Official Transcript of Proceedings
NUCLEAR REGULATORY COMMISSION

Title: Advisory Committee on Reactor Safeguards
(ACRS), NuScale Committee

Date: March 21, 2019

“ACRS Presentation Chapter 10 – Steam and Power Conversion System,” PM-0219-64501, Revision 1

Power Island Layout

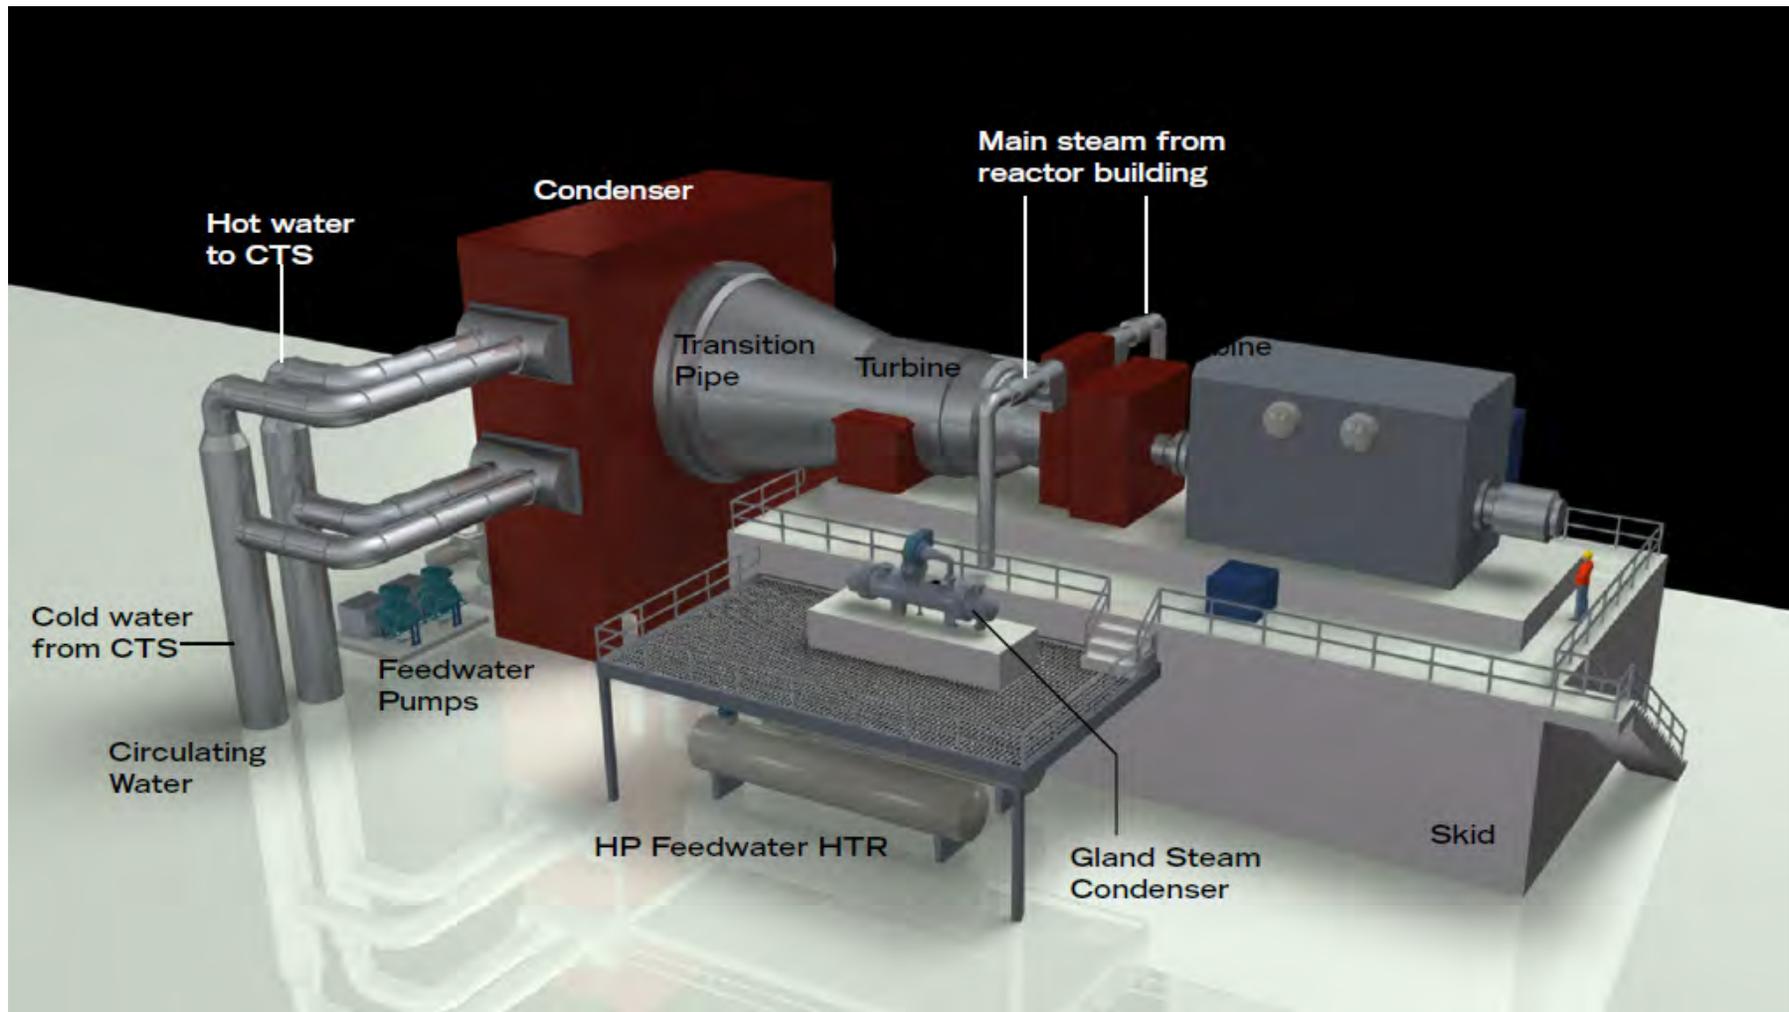
4 MEMBER BLEY: And not to sound like a
5 broken record, I'm staring at your arrangement drawing
6 and you said, this arrangement gets you better
7 balanced steam flow, but you have a pipe that comes
8 out from the reactor, turns up at a right angle, turns
9 again and goes into the turbine. I can't imagine why
10 that makes a difference whether the turbine is sitting
11 this way or this way.

19 MR. HOUGHTON: I do not have an analysis
20 available on that. There's not, in the -- it's not in
21 the design certification. But I'll say, that's a
22 detail that we continue to look at, the tradeoff.

10.3 Main Steam System

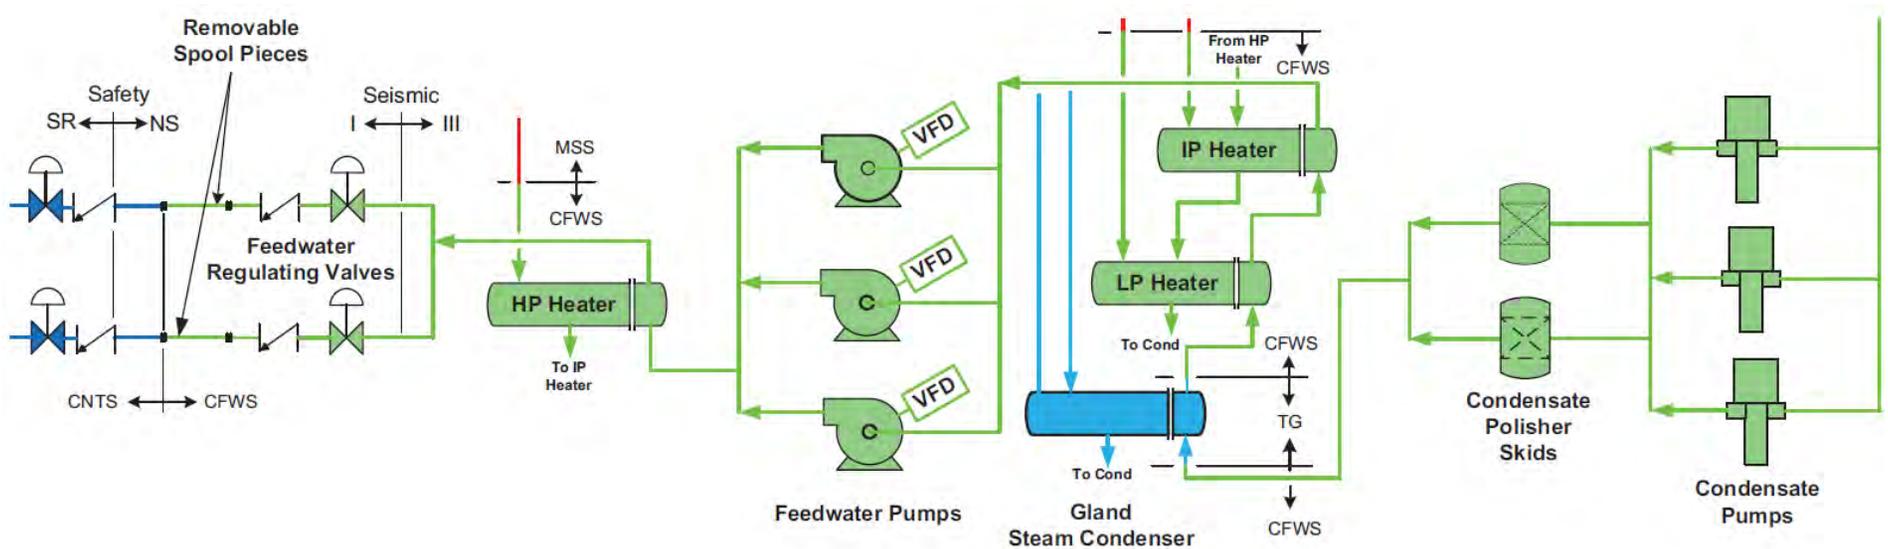
23 Second question. Lower left-hand corner
24 of this image, you show the main feedwater isolation
25 valves and check valves immediately upstream. Is that

21 CO-CHAIR SUNSERI: -- when I first saw this
22 drawing, I had to scratch my head a little bit, and
23 then I realized that the main steam safety valves are
24 downstream of the main steam isolation valves. And I
25 read an explanation why that is an acceptable

17 MEMBER KIRCHNER: I had the same question,
18 Harold. I expected you would use the same valve on
19 either side of that blue or red.

19 MEMBER BALLINGER: This figure is more of
20 a cartoon, because there's got to be other piping and
21 stuff. There's good news and bad news for ball
22 valves, right? The good news is, they're ball valves.
23 The bad news is, they're ball valves.

23 This is allowed by code. The ASME code
24 allows you to remove the overpressure protection, if
25 you have designed to preclude its use. And so, we

22 MR. HOUGHTON: Correct. Up to the red
23 valve, the secondary main steam isolation valve is
24 designed up to 2,100 PSI, the same as the reactor
25 coolant system.

9 MR. HOUGHTON: The design of the blue valve
10 is a hydraulically operated ball valve that we've been
11 working with Curtiss-Wright Enertech for a number of
12 years. And we'll describe that valve in detail when
13 we bring Chapter 6 for presentation. It's common for
14 all of our containment isolations.

9 MR. HOUGHTON: Thank you, good question.
10 This is a simplified sketch, there are bypasses on
11 each of these valves.
